Re: Nottingham Hills Subdivision

Lot Line Revisions to Lot 19 & 21 1 Lot Re-Subdivision Lots 19& 21

Date: November 9, 2020 To: Gesick & Associates, P.C.

Subject Property: Upper Kensington Dr - Lots 19 & 21, East Lyme

Drawing: 20-018h

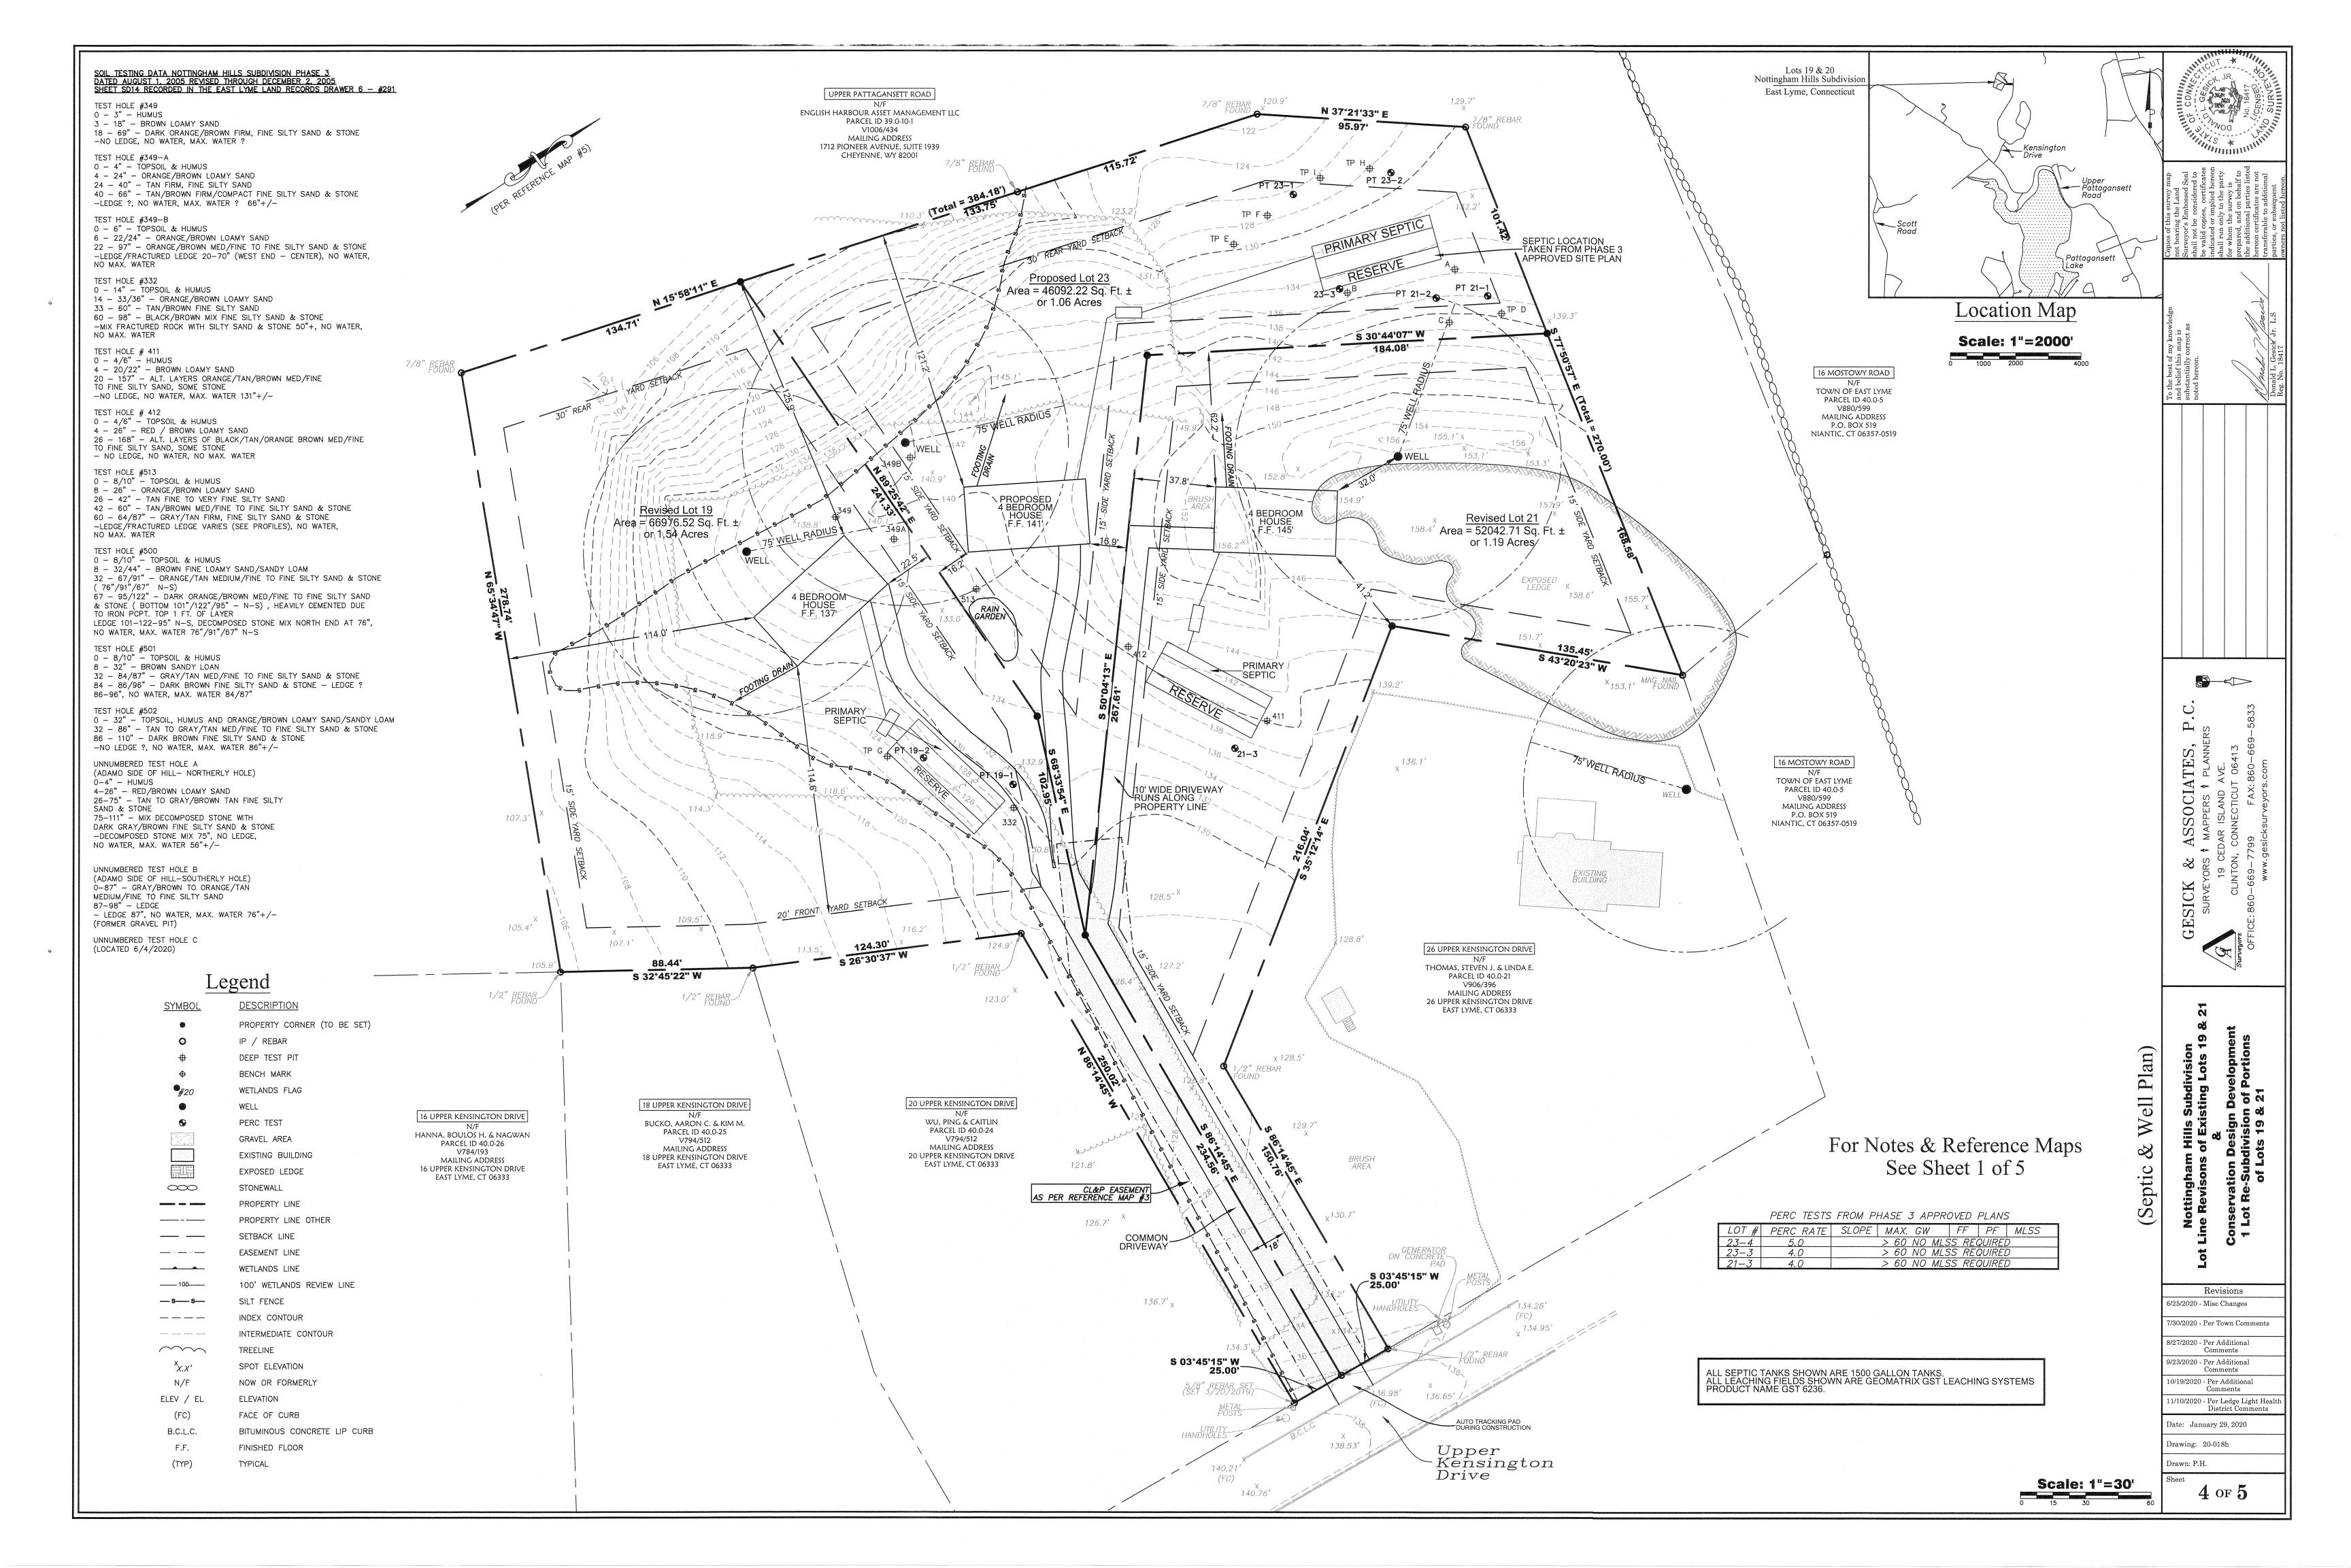
Revised Lot 19 is recommended <u>conditionally</u> suitable, subject to the proposed well location being altered on individual lot site plans to satisfy the required 25' setback from the foundation drains shown around the perimeter of the new home. It is recommended that the well also be relocated resulting in the entire well arc being kept on the property it serves. It appears the revised lot lines affecting this lot configuration would allow both of those revisions to be achieved at the time of building permit application.

Proposed Lot 23 & Revised Lot 21 are <u>not</u> recommended suitable in their current condition and the following issues are to be addressed:

- Both the Primary and Reserve septic areas for Lot 23 are proposed where unsuitable soil conditions were encountered. Unsuitable soil conditions include areas with less than 18 inches of soil above maximum groundwater or less than 4 feet of soil above ledge rock.

- 2. Lot 21 as proposed shows the Primary leaching system area where unsuitable soil conditions were encountered around the perimeter of the system. In the case of existing single-family residential building lots created prior to January 1, 2007, an area with <u>potentially</u> suitable soil must be identified. Potentially suitable soil contains less than 4 feet of existing soil above ledge rock but at least 2 feet of which is naturally occurring soil. The applicant could use the plan (at the risk of the property owner, no guarantees are provided of suitability by LLHD) to make the untuiable area serving existing Lot 21 suitable according to health code (minimum 4' to ledge). To use said plan as a guidance plan, the following must be conducted:

- e. Once this process is complete and all steps approved by LLHD, the proposed septic areas may be approved as suitable by LLHD.
- 3. MLSS calculations are not noted. Based on non-typical ledge encountered in most test pits, MLSS applies to all proposed lots.

- 4. Proposed underground electrical line or other underground utilities are not shown.
- 5. A proposed water treatment wastewater discharge system is recommended to be shown on the plans for potential treatment of well water.

- 6. A description of the proposed septic tanks (size and type) are not included.
- 7. A description of the proposed leaching system for each lot is not provided and thus it cannot be determined whether Effective Leaching Area is satisfied for each proposed home.

- On page 3 and 4 of 5 we relocated the system area, and septic tank, to a location in front of the house Test Holes ("T.H.") 411 & 412, and 4 min perc test location which were all identified in the Nottingham Hills Subdivision Phase 3 plans and have been included at all times on the current applications plans. As noted on page 4 of 5 of the current plans T.H.'s 411 & 412 both were dug to a depth's of over thirteen feet (13') T.H. 411 was dug to 157". T.H. 412 was dug to 168".
- We relocated the proposed driveway closer to the southwestern property line.
- We relocated the proposed well location and well arc.
- We relocated the rear property line of this lot to add additional area to proposed lot 23.
- We added notes to page 4 of 5 to reflect each lot would have a 1500 gallon septic tank and use a Geomatrix product GST 6236 leaching system.

We relocated the boundary of this lot to allow the use of the code compliant septic area approved for lot 21 in the Nottingham Hills Subdivision Phase 3 plans for the proposed lot 23 in the current application. This system area, both Primary & Reserve, was plotted exactly as was previously approved using test holes A & B and the perc test identified in both the aforementioned "phase 3 Plans" as well as the current applications plans page 4 of 5.
